NAVAL MEDICAL RESEARCH INSTITUTE
BETHESDA, MARYLAND

81 - 47
HUMAN ENGINEERING EVALUATION
OF THE
HYPERBARIC RESEARCH FACILITY
(PHASE 1)

J.I. Brady and M.D. Curley

Fig. 24. Recommended bunk arrangement when entire complex is at depth.

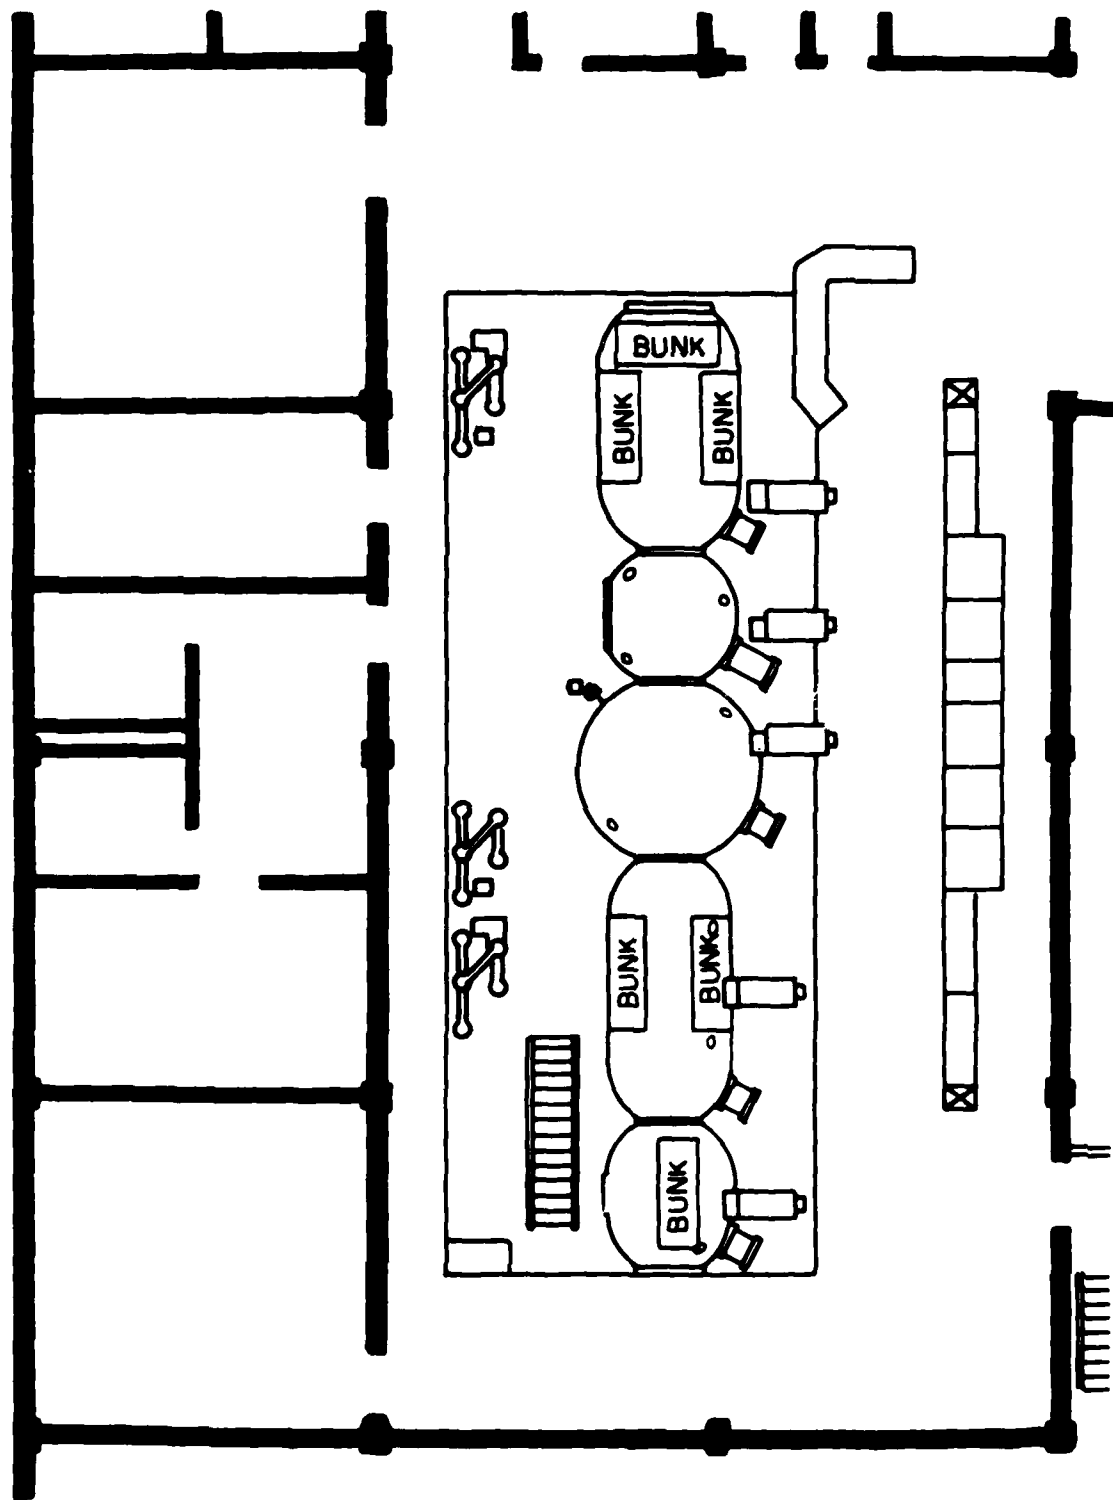
- (38) The removable bunks in C chamber (Fig. 23) should be moved to permanent locations in other chambers. See Fig. 24 for recommended locations. (Priority 2)

Fig. 28. Present design of the gas analysis patch panel.

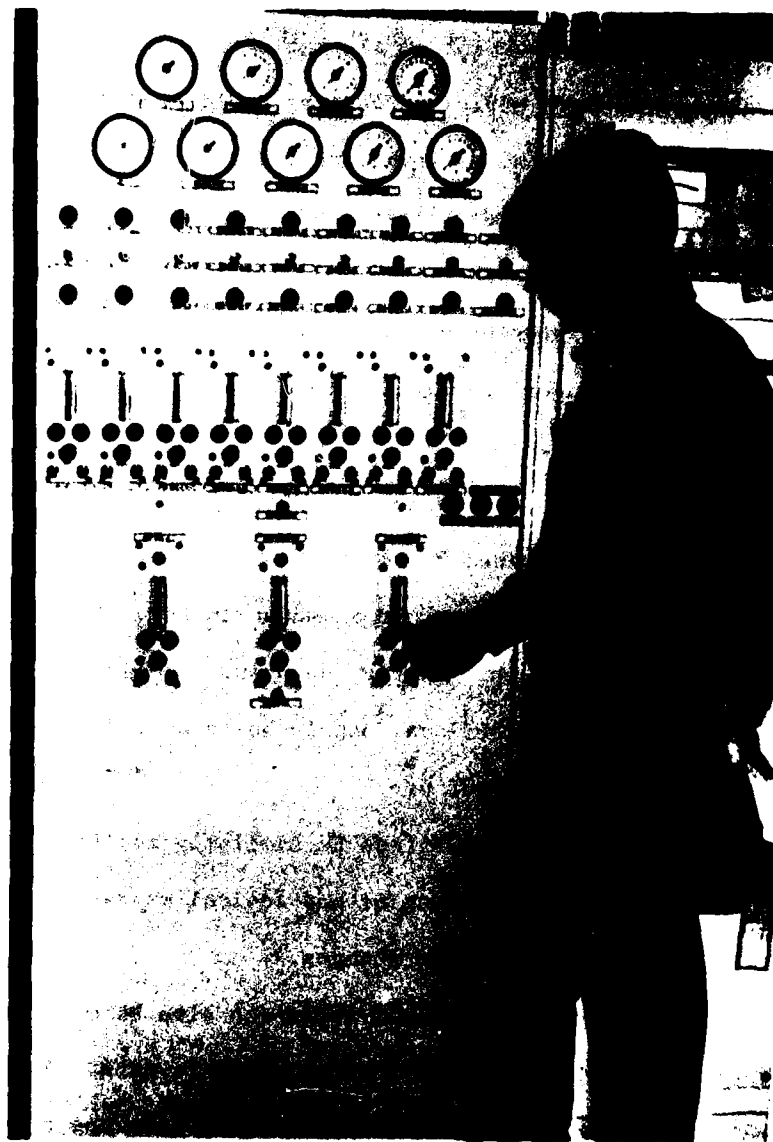
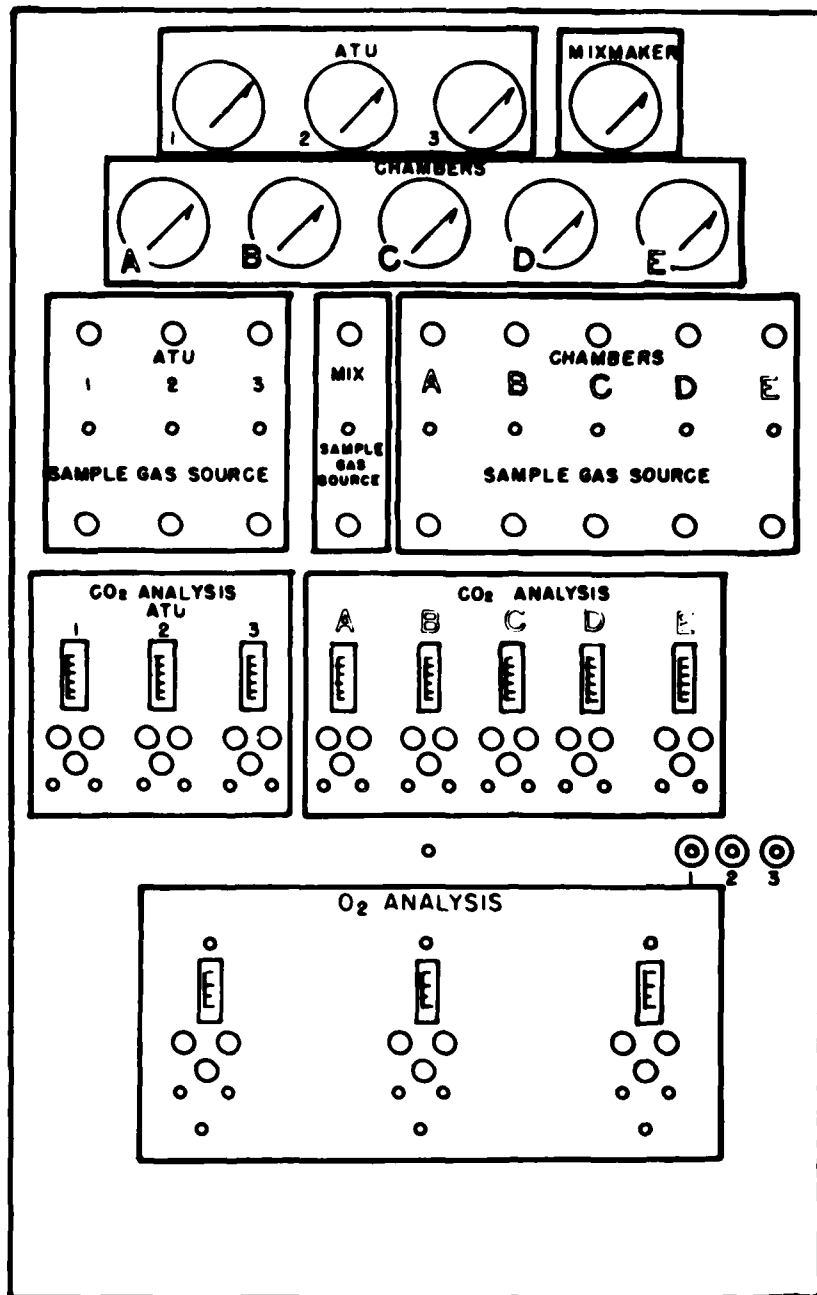
(52) Figure 28 shows the present design of the gas analysis patch panel. As can be seen, no attempt was made to group components by function or to color-code them in a manner to clarify their purpose to an

operator. Figure 29 shows the recommended changes. This layout does not require the movement or alteration of any of the hardware (although several more efficient designs could be devised). It simply employs functional grouping and color coding. This design should improve operator recognition and readability while reducing errors. (Priority 2)

Fig. 30. Present design of gas analysis instrumentation panel.

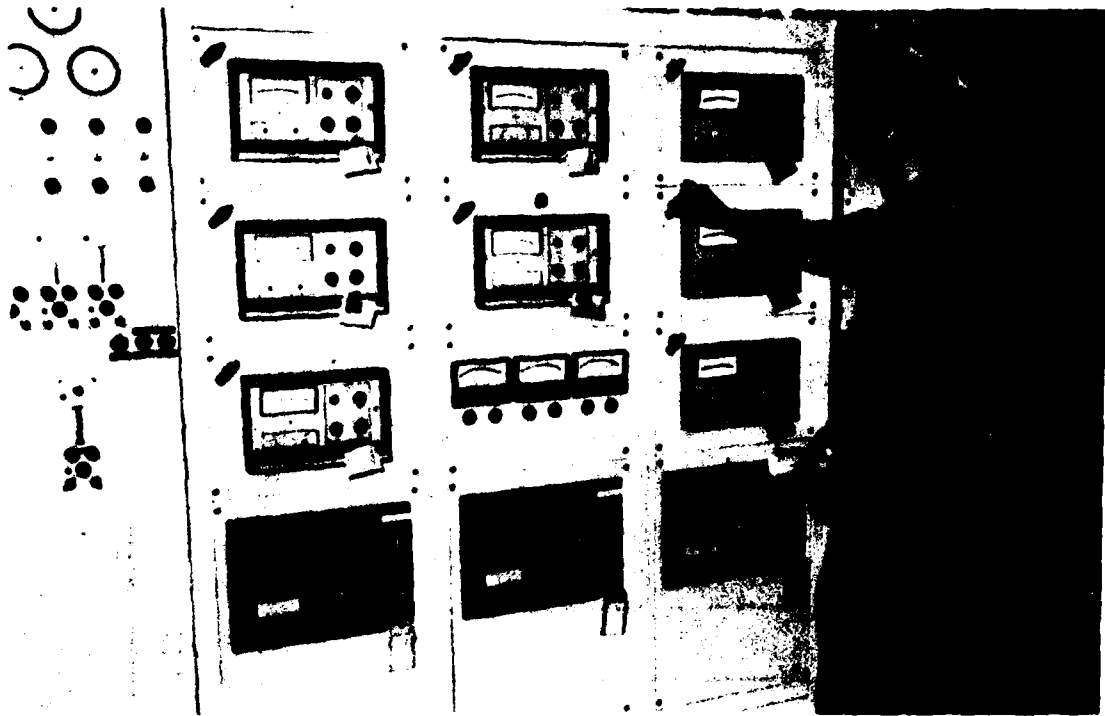
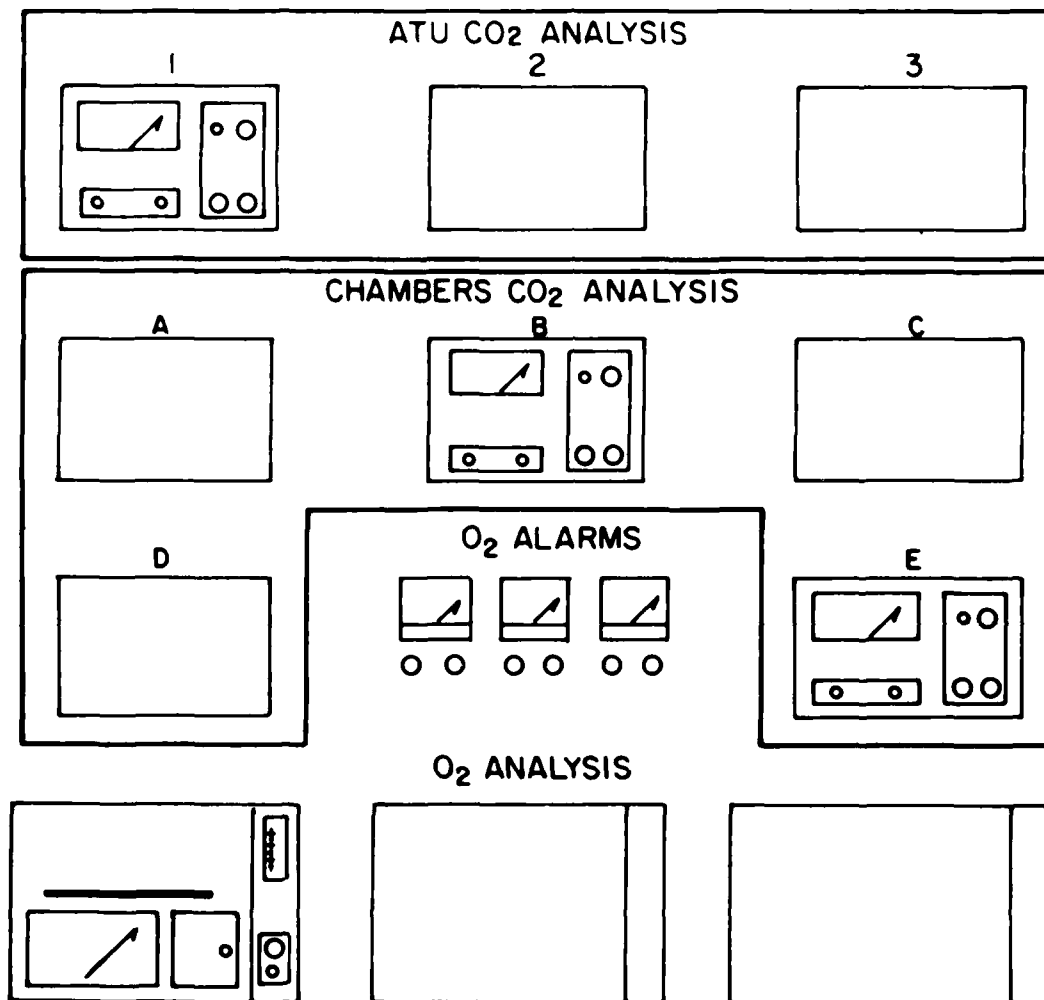
- (53) Figure 30 shows the present gas analysis instrumentation panel. The recommended changes are similar to those above (see Fig. 31). (Priority 2)
- (54) Figure 8 showed the face of a local control panel. Greater clarity of function can be obtained by concise gas paths and simple noncoded labeling. The recommended scheme is shown in Fig. 32. (Priority 2)

Fig. 33. Current configuration of a master console operating panel.

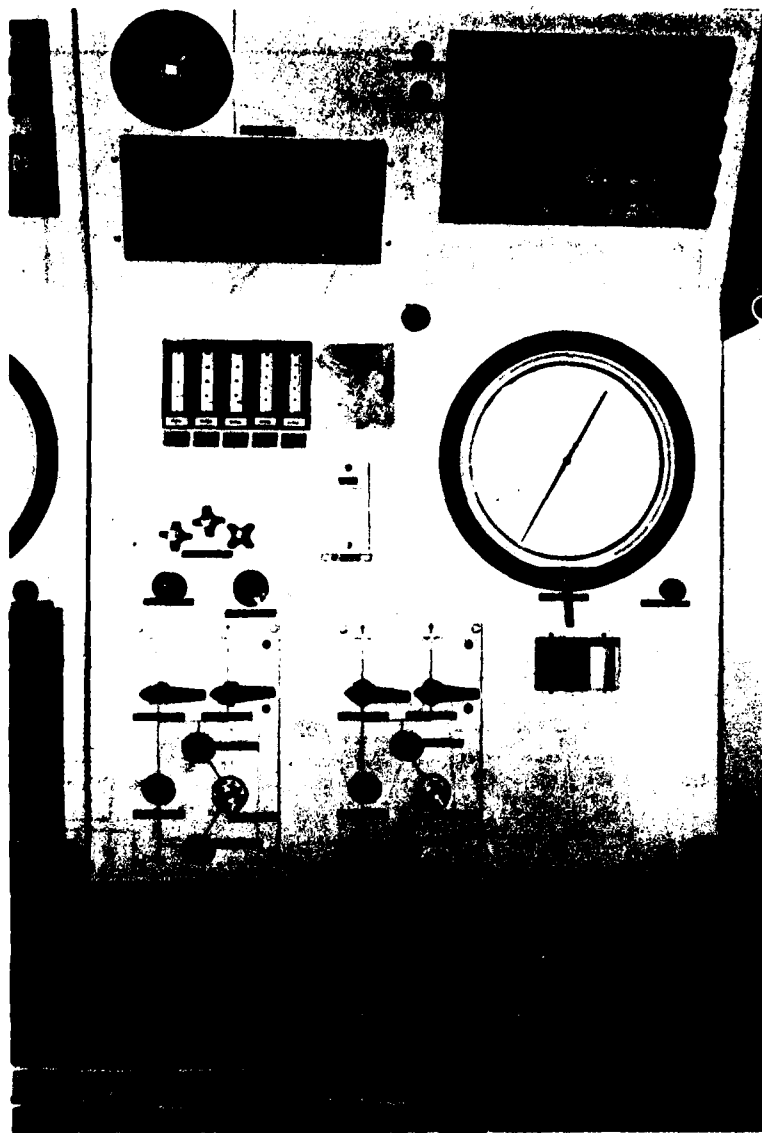
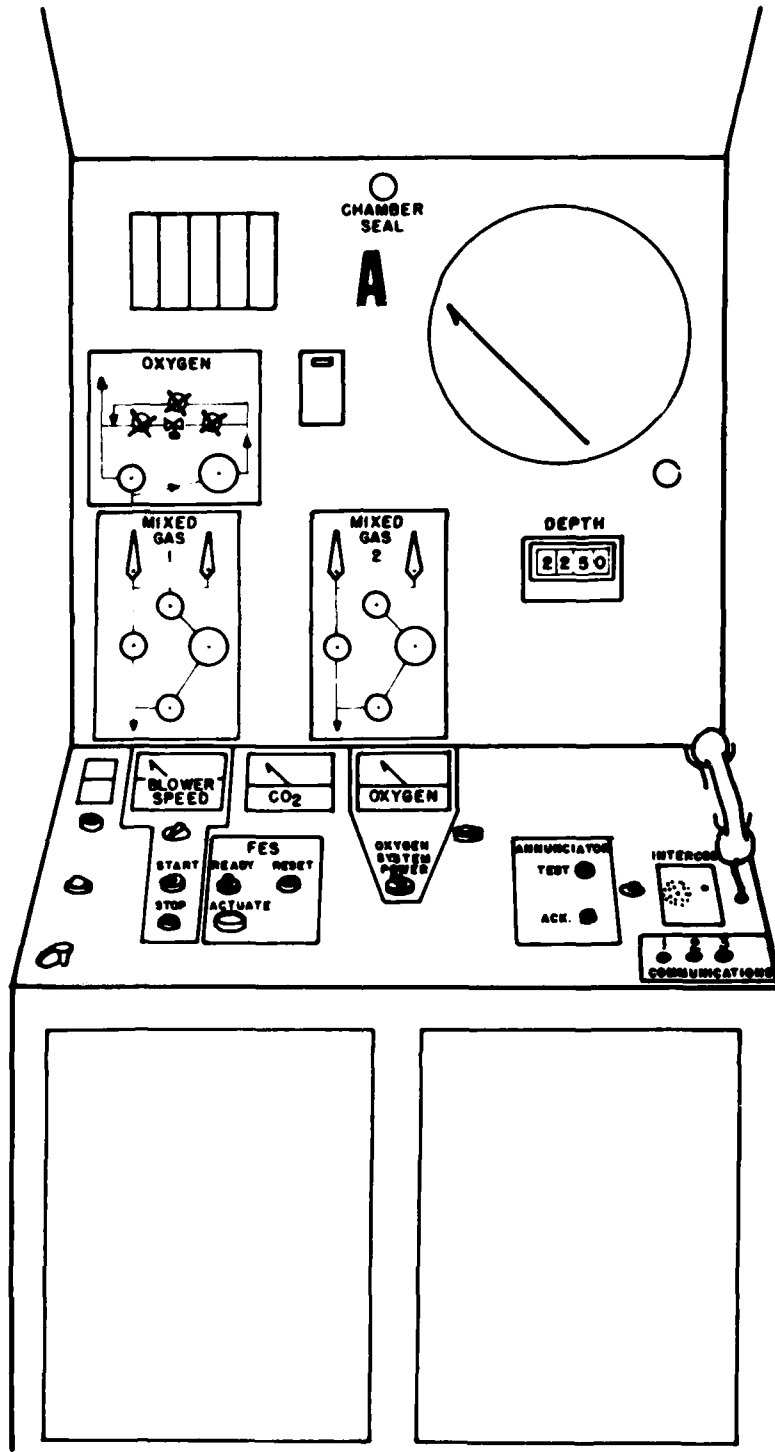
- (56) The operating panels (Fig. 33) can be similarly modified to improve their organization in a meaningful and logical manner. Figure 34 shows a layout for recommended changes. (Priority 2)
